Access Compliance Report

Public Rights-of-Way

(Curb Ramps)

Intersection ID: 43669	Main Street: CORSICA_FOREST_DR	Cross Street: ASHETON_CREEK_DR	Location: W
ADA ID: 6891FE6F18DF	Ramp Type: PerpDiag	Initial Pass/Fail: Fail	Overall Compliance: No
Severity Score: 35			
Codes/Mitigation Info/Possible Solution		Field Measurements/Component Compliance

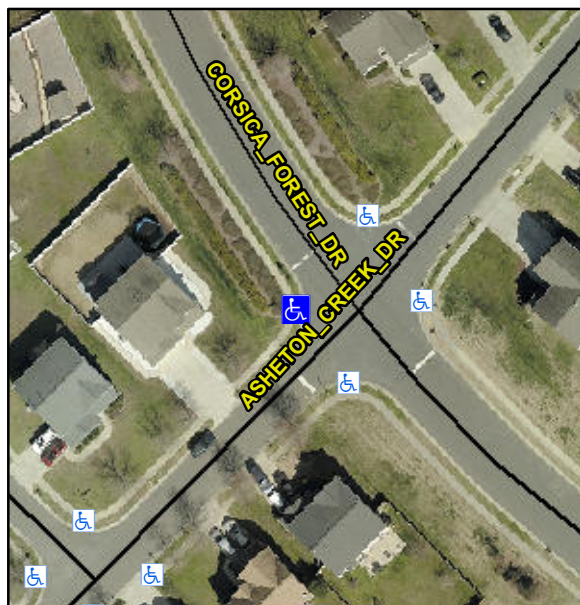
R304.5.1, R304.2.2, R304.5.3

Compliance	Description	Data	Compliance	Description	Data
N/A	Ramp Length (in)	44.0	No	Ramp Slope (%)	13.4
No	Ramp Width (in)	40.0	No	Ramp XSlope (%)	4.5
N/A	Flare Type LT	N/A	N/A	Flare Type RT	N/A
N/A	Flare Slope LT (%)	N/A	N/A	Flare Slope RT (%)	N/A
N/A	Flare Traversable LT?	N/A	N/A	Flare Traversable RT?	N/A
N/A	Landing Length (in)	N/A	N/A	DWS Provided?	N/A
N/A	Landing Width (in)	N/A	N/A	DWS Contrast?	N/A
N/A	Landing Slope (%)	N/A	N/A	DWS Length (in)	N/A
N/A	Landing X Slope (%)	N/A	N/A	DWS Full Width?	N/A
N/A	Landing Curb? (Y/N)	N/A	N/A	DWS Offset (in)	N/A
N/A	Shared Landing?	N/A			
N/A	Gutter Ponding?	N/A	N/A	Gutter Slope (%)	N/A
N/A	Gutter Lip Ht (in)	N/A	N/A	Gutter X Slope (%)	N/A
N/A	Painted X Walk1?	No	N/A	Painted X Walk2?	No
	X Walk 1 Direction	To SE		X Walk 2 Direction	To NE
N/A	X Walk 1 Width (in)	N/A	N/A	X Walk 2 Width (in)	N/A
	X Walk 1 Slope (%)	2.4		X Walk 2 Slope (%)	3.2
	X Walk 1 X Slope (%)	2.6		X Walk 2 X Slope (%)	3.6

Remove & Replace Curb Ramp With Two New Directional Ramps or Equivalent.
